DISCUSSION of:

Ground Improvement Using Preloading with Prefabricated Vertical Drains

Bengt H. Fellenius, Dr. Tech., P.Eng., Canada; email: bengt@fellenius.net

Figure 1. Settlement measured at the benchmarks shifted 10 days.

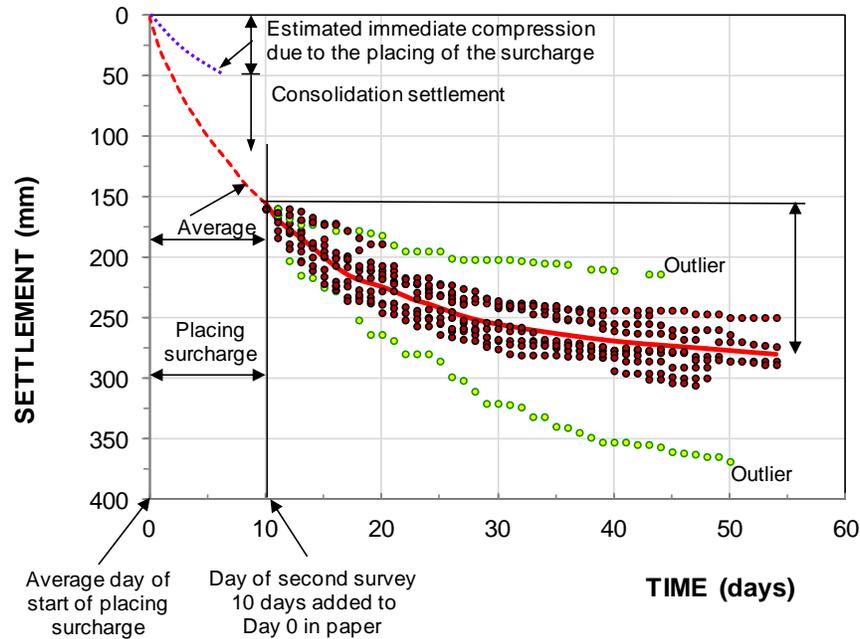
The authors report, that the first survey of the benchmarks was taken before the 3.0-m surcharge was placed across the test area. The first day of settlement measurements for the twelve benchmarks was the date of the second benchmark survey, which was carried out only when all of the surcharge had been placed to the full height over the test area. The time between the first and second surveys—and the placing of the surcharge—ranged from a few days to twenty days. Because the times between the placing of the surcharge and the second survey differed for the benchmarks, the amount of settlement that had occurred at the time of the second survey also differed between the benchmarks. This explains some of the significant scatter displayed in the authors' Figure 13. I have re-plotted the measured settlements in Figure 1 to a common starting point at the average start settlement of 160mm and added 10 days to the authors' measurement days to indicate the average duration of placing the surcharge, which took place before the second survey. During this time, immediate compression and some consolidation will have occurred. As indicated, I estimate the immediate compression to be about 50 mm. I have also added an average curve and extrapolated it back to the origin (the average excludes the two outlier records). All benchmarks appear to show that most of the consolidation had developed at the time the last survey was made.

Figure 2. Settlement measured at the benchmarks normalized to the average end values.

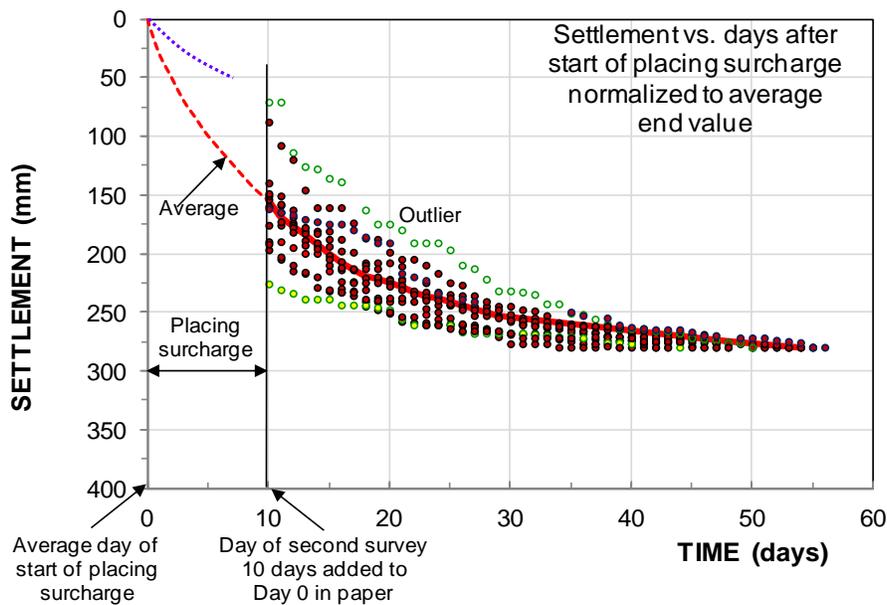
Figure 2 shows the measured final settlements are normalized to the average final settlement (280 mm). There is still much scatter between the curves, but now the approximate start date for each curve can be obtained by sliding the curves left or right until the best agreement to the average curve is obtained as shown in Figure 3. The removal of much of the scatter—the agreement between the time-settlement curves—is of course to some extent fictitious as the benchmark measurements cannot be expected to be all that similar; a natural variation must have taken place, not least with regard to the thickness of the soft clay layer. However, I believe that the figure suggests a reasonably realistic day for the start of placing the surcharge.

Figure 3. Settlement measured at the benchmarks adjusted to obtain the approximate start day.

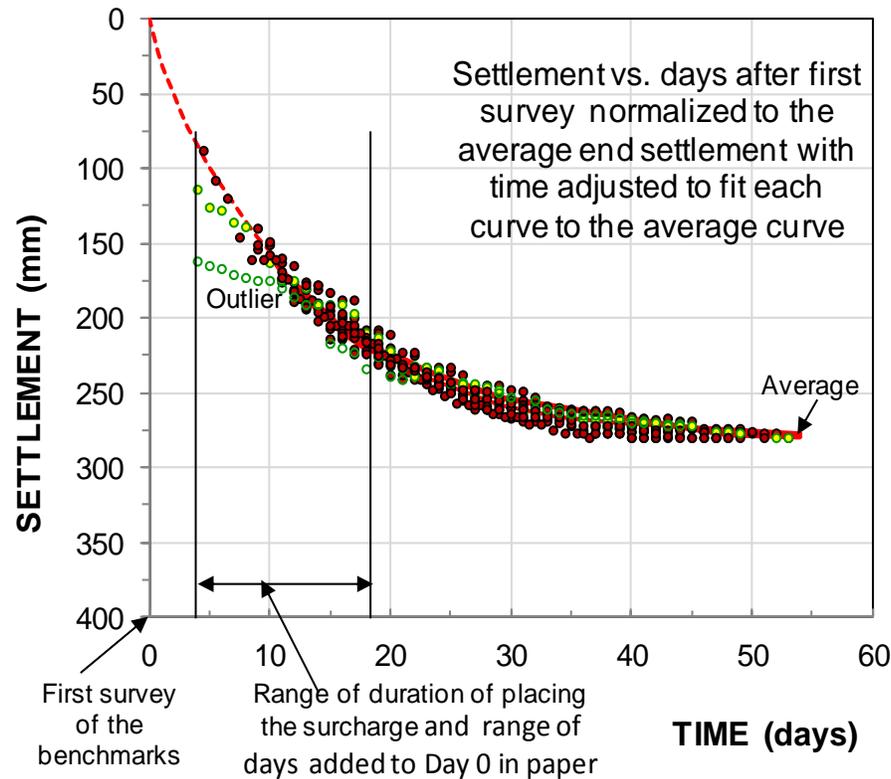
The average curve shown in Figure 3 can now serve as reference to a back-calculation of the time-settlement development for the wick-drain project to determine compressibility and coefficient of consolidation of the soil layers. The back-calculation consists of applying the theory of pore pressure dissipation in fine-grained soils (consolidation) due to radial flow (Barron 1948, Kjellman 1948, and Hansbo 1960; 1979) is based on radial flow toward a circular drain in the center of a cylinder of homogeneous soil with an impervious outer boundary surface). The theory is summarized in the Kjellman-Barron formula, Equation 1. The Kjellman-Barron formula is based on the assumption of horizontal (radial) flow only and a homogeneous soil.

Figure 4. Average measured and calculated settlements.

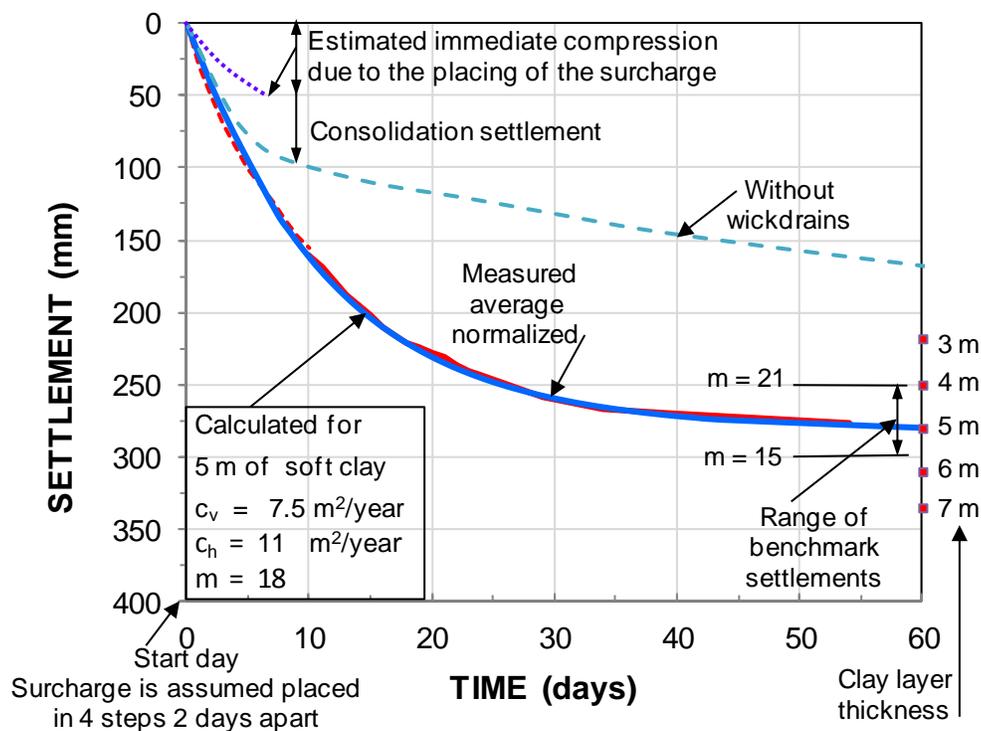
The results of the back calculation are shown in Figure 4 together with the average curve of the measurements. In order to show the sensitivity of the clay layer thickness and modulus number, the figure also shows the final settlement for soil layer thickness ranging from 3 through 7m and the final settlement resulting from modulus numbers of 15 and 21. The figure also shows the settlement during the first 60 days that would have occurred had there been no wick drains (for this input, I used the authors' 7.5 $m^2/year$ c_v -coefficient).

Considering that my data reduction is quite different to that of the authors, my back-calculated c_h -coefficient (11 $m^2/year$) agrees well with the authors' laboratory-established value (14 $m^2/year$). The difference could be taken to represent the effect of a smear zone. However, considering all the uncertainties involved, I believe the agreement to be entirely fortuitous.
